Vintage Denim Apparels Ltd. (Wet Processing)

Boherarchala, Sreepur, Gazipur.
(24.190945N , 90.405580E)
5th February, 2018

Observations

Water causing damage

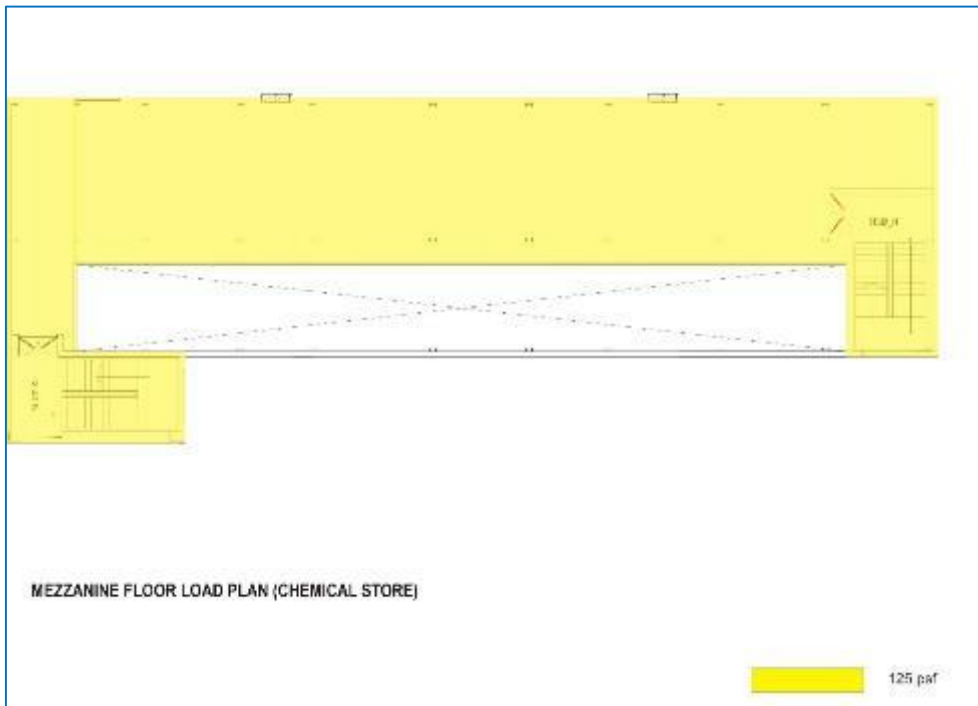
Steam rejection causing constant wetting. Unmanaged roof drainage causing corrosion to façade and structure.

Water clogging at roof

Paucity in drawings and mismatch in truss section

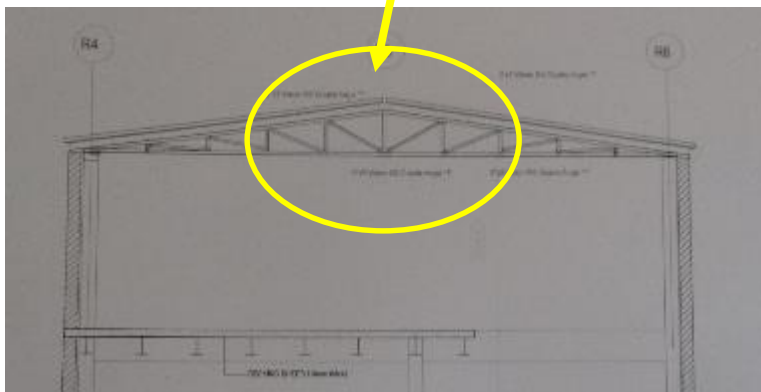
Purlin layout and connection details were not available on provided drawings. On the other hand, truss pattern did not match with as-built condition.

Truss section

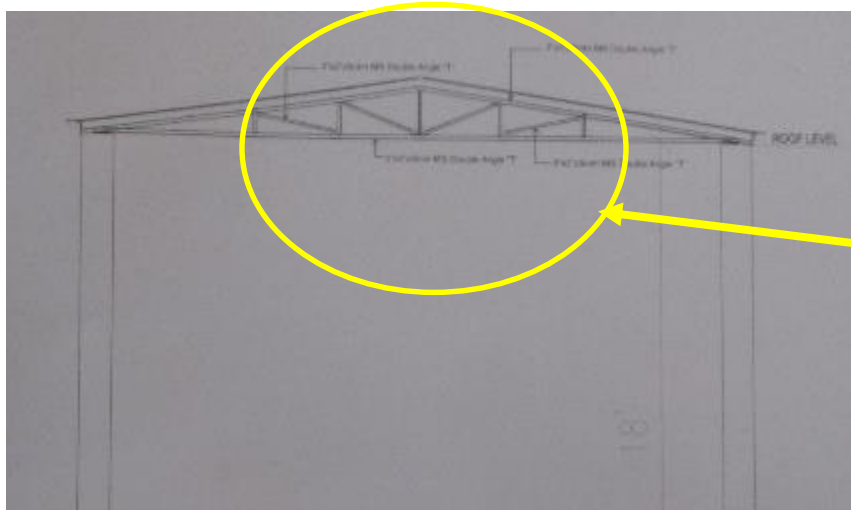
Connection details were not available on provided drawings. Truss patterns did not match with as-built condition. Single truss member were found in as-built condition whereas double angle truss member were shown on drawings.
